### **ADDENDUM # 4 Bid 20C6, Waverley Elementary School - New Construction**

#### **ADDENDUM NO. 4**

RE: **WAVERLEY ELEMENTARY SCHOOL REPLACEMENT**

EDGE STRIP DETAIL

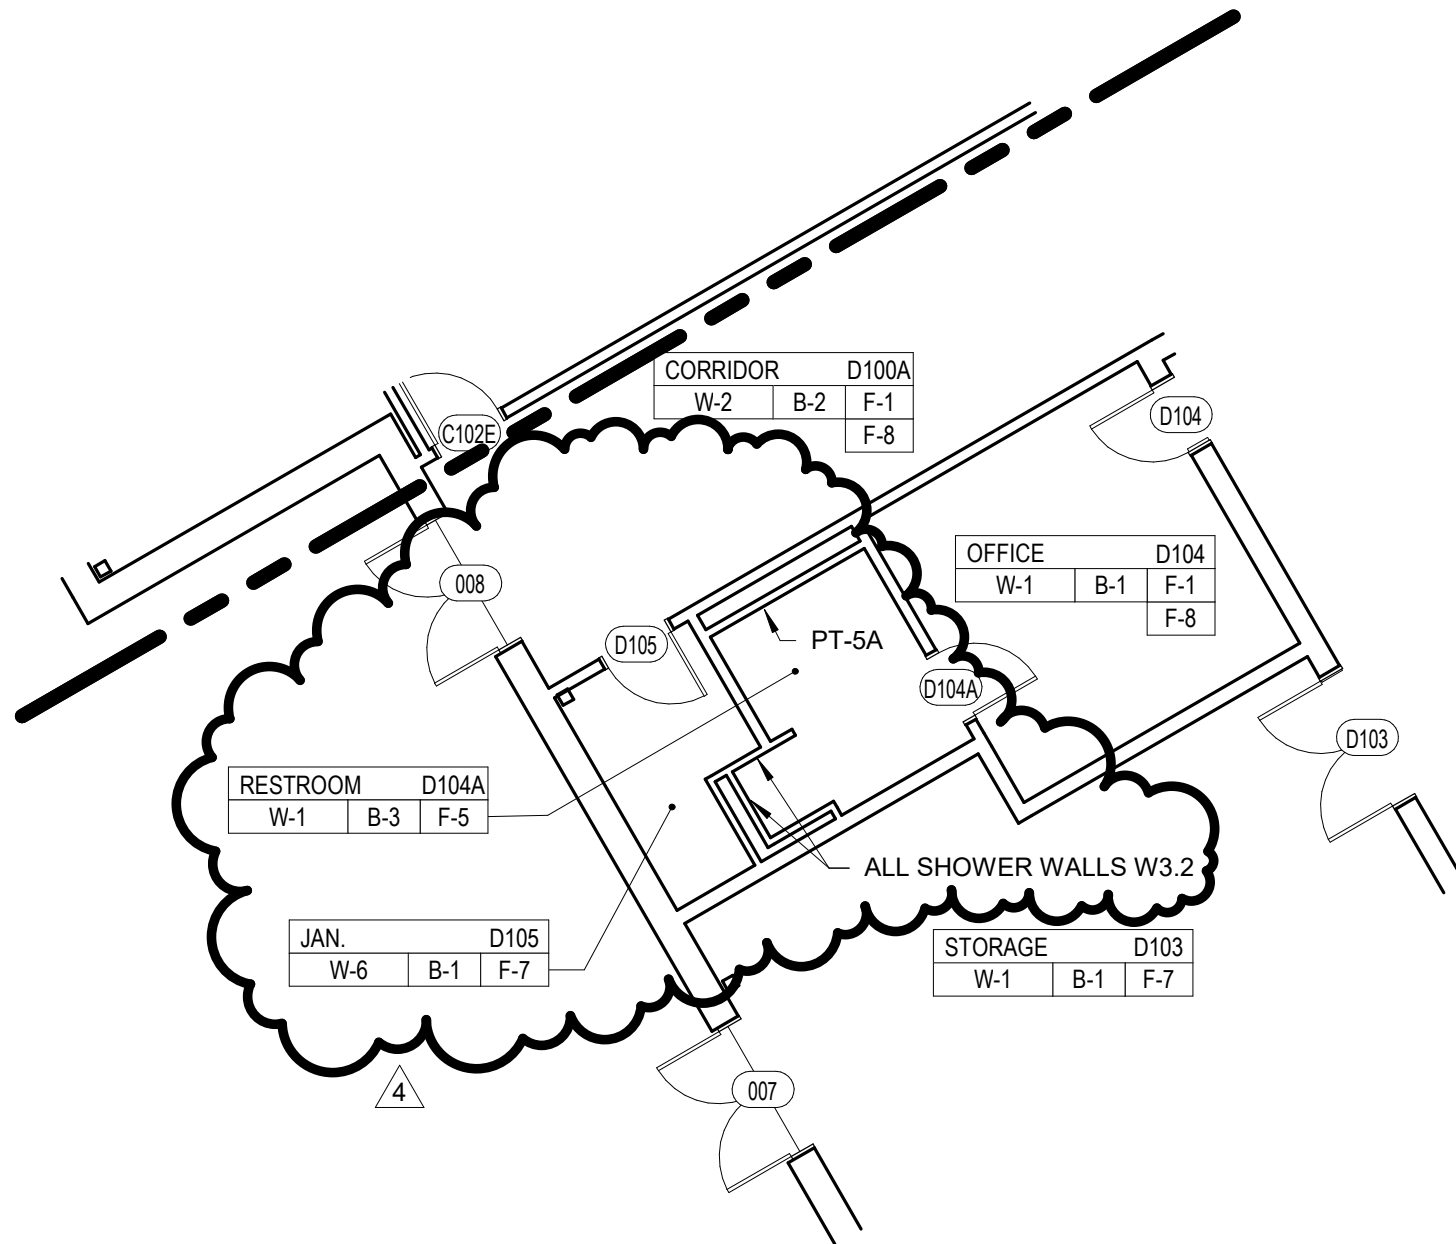
- **REMOVE** “Restroom Signage PT-5” note, all locations.
- 11. **REVISE** Drawing Sheet A9.12 – ENLARGED FINISH ELEVATIONS; Issued for Bid, dated 03/06/2020.
  - **DELETE** drawing 12/A9.12 (redundant).
- 12. **REVISE** Drawing Sheet A9.14 – FINISH DETAILS; Issued for Bid, dated 03/06/2020.
  - **REVISE** title of drawing 3/A9.14 to be “ELEVATION (TYP) - W-1A.”
  - **ADD** detail 1/ADD4.2 (included as a sketch as part of this addendum); detail to be 13/A9.14 in final drawing set.

ADDED TO SET AS DETAIL 13/A9.14.

1 PARTIAL FIRST FLOOR FINISH PLAN - AREA D  
 ADD4.3 1/8" = 1'-0"  
 FROM 1 / A9.4

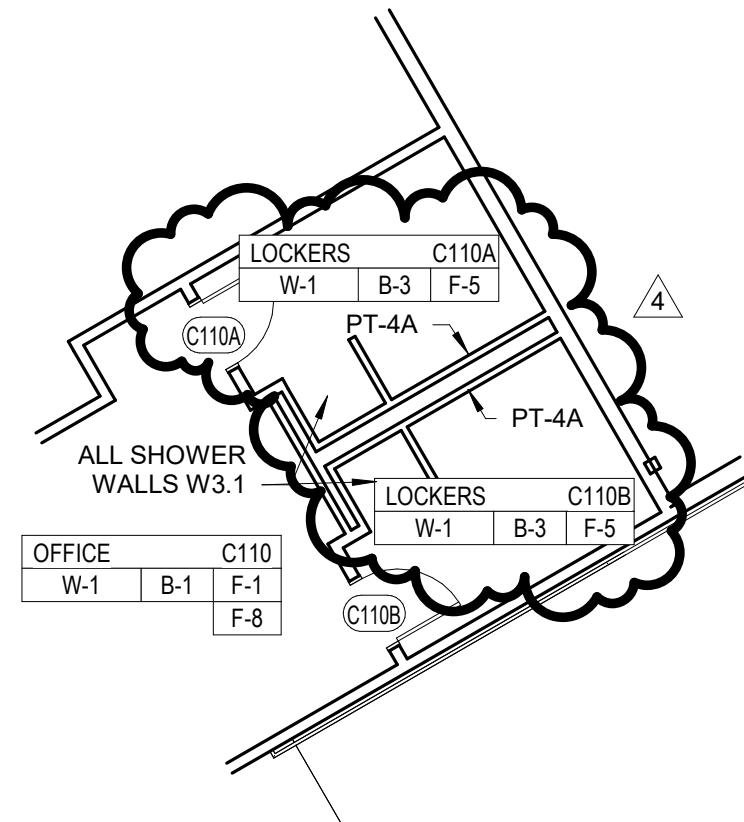
- **REPLACE** “W-3.2” with “PT-5A” in areas indicated. Shower walls in D104A to remain “W-3.2”; see sketch 1/ADD4.3.
  - **REMOVE** “Restroom Signage PT-5” note, all locations.

2 PARTIAL FIRST FLOOR FINISH PLAN - AREA C  
 ADD4.3 1/8" = 1'-0"  
 FROM 1 / A9.3

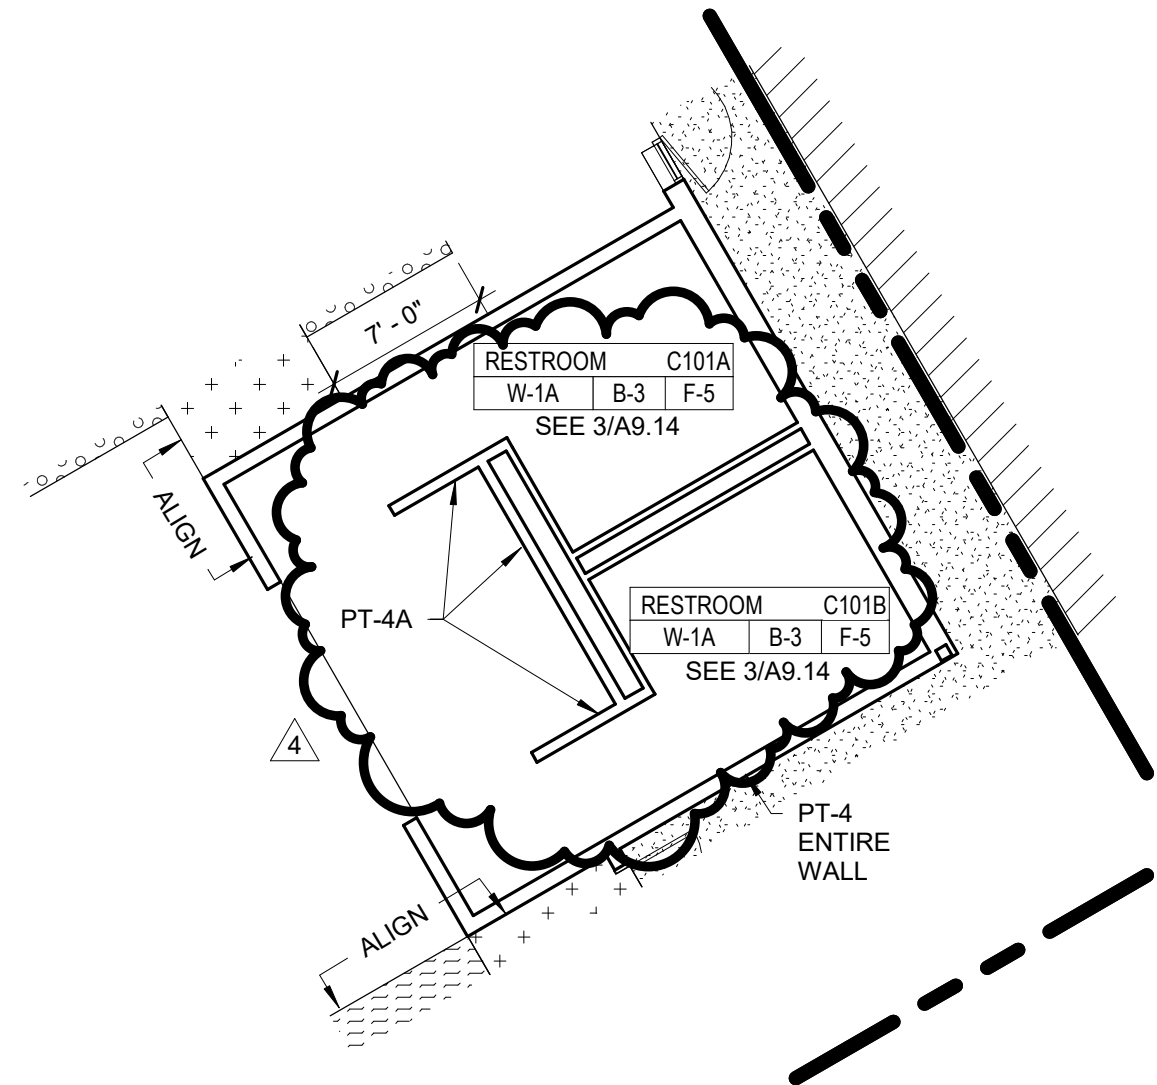
- **REVISE** wall treatment to “W-1A” for C101A and C101B; see sketch 2/ADD4.4.
  - **REVISE** wall treatment to “W-1” for C110A and C110B; see sketch 2/ADD4.3.

- **REPLACE** “W-3.1” with “PT-4A” in areas indicated. Shower walls in C110A and C110B to remain “W-3.1”; see sketch 2/ADD4.3.
  - **ADD** “W-1A” designation to rear walls (shared with C112) in C114A and C114B; all other walls to remain “W-2”.
